CALIFORNIA INSTITUTE OF TECHNOLOGY
Laser Interferometer Gravitational Wave Observatory (LIGO) Project

To: D. Coyne
From: L. Jones 
Phone: 2970
Refer to: LIGO-E960019-00-B
Date: February 6, 1996

Subject: Request for design check: valve soft support

VALVE SOFT SUPPORT CONCEPT

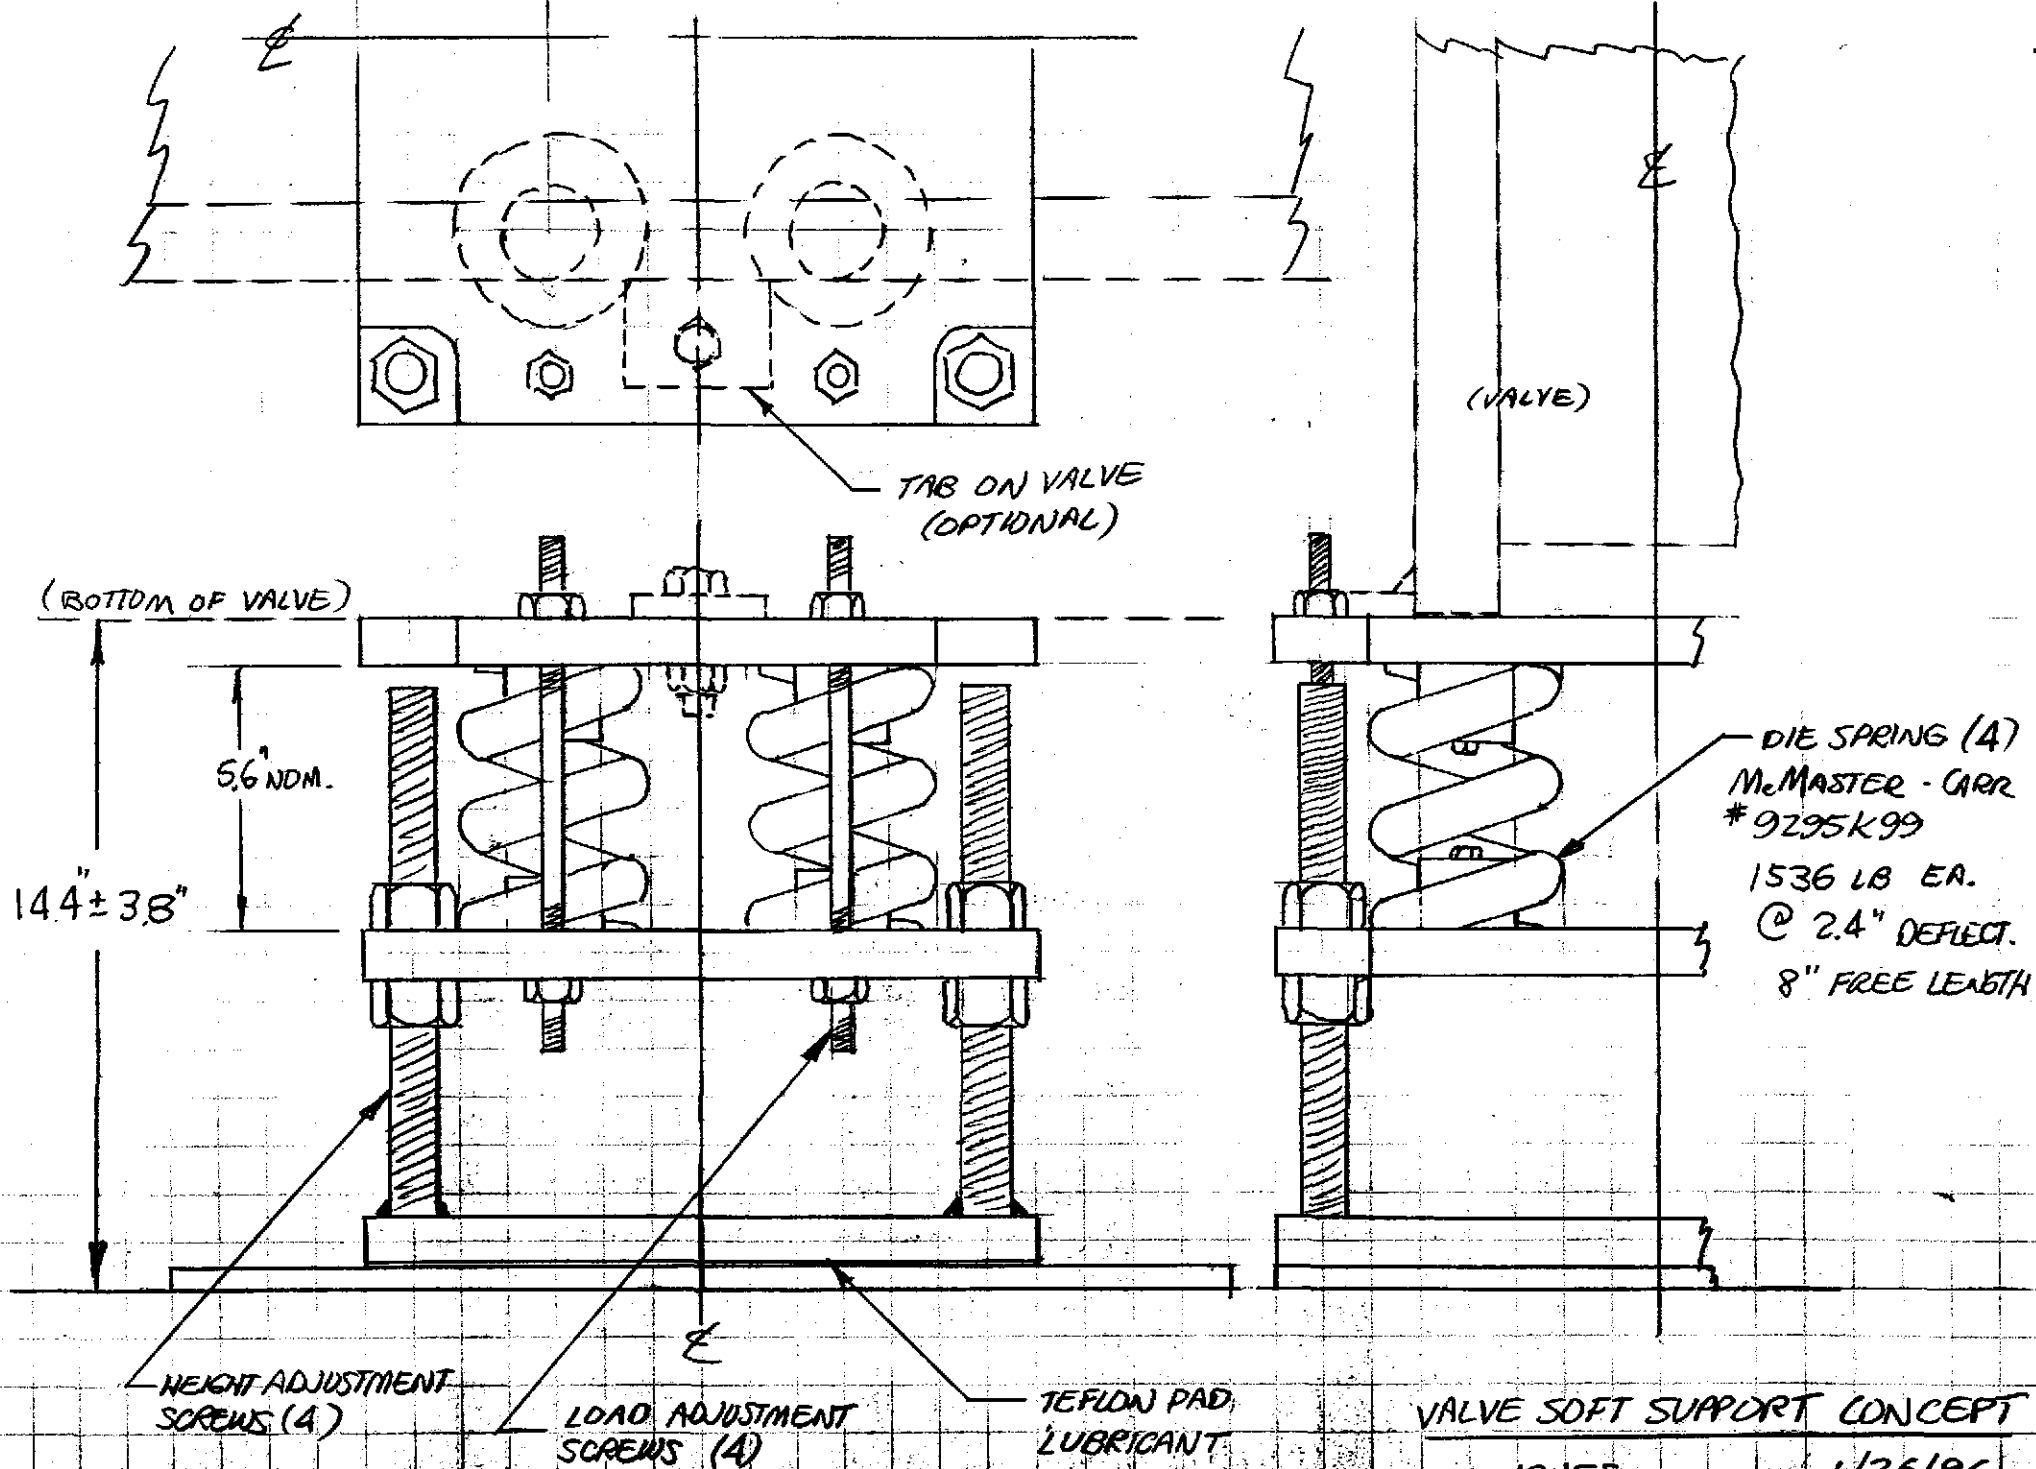
The attached sketch is a proposed design for a soft valve support, to be used at each BT/VE interface gate valve, generated to demonstrate a concept for CBI after they had responded with an unacceptable plan to use two catalog spring cans for the task. CBI gave us a reasonable price for detailing this sketched unit, fabricating it, and installing it when they install the valves. However, they refuse to be responsible for the design of an item that supports someone else's product (it's a good thing that they don't build bridges!).

I believe that we can impose a design, taking the responsibility for a fairly simple task. I would like for you to check the attached sketch, and see what modifications may be called for. Its performance requirements are as follows:

- suited for use with both valve sizes (112 & 122 cm size; dwgs. attached)
- support the weight of the valve
- allow for adjustment of that load
- allow for adjustment of the position of the valve: +/- 3", vertically & laterally

The scale of the sketch is 1/4"=1". The purpose of the small studs is for assembly and installation convenience only; these are loosened or removed during operation. The spring locating blocks can be replaced by a counterbore, at the possible expense of thickening the middle plate. Both the center tabs and floor anchors are optional, depending upon friction from the vertical load to keep the support near the center of the valve. "Racking" of the springs is controlled by tapping the assembly with a hammer to move it during anchor adjustments. I haven't yet found out the OD of the bolted flange connecting to the 112 cm valve; there's a potential interference there, with the valve adjusted low.
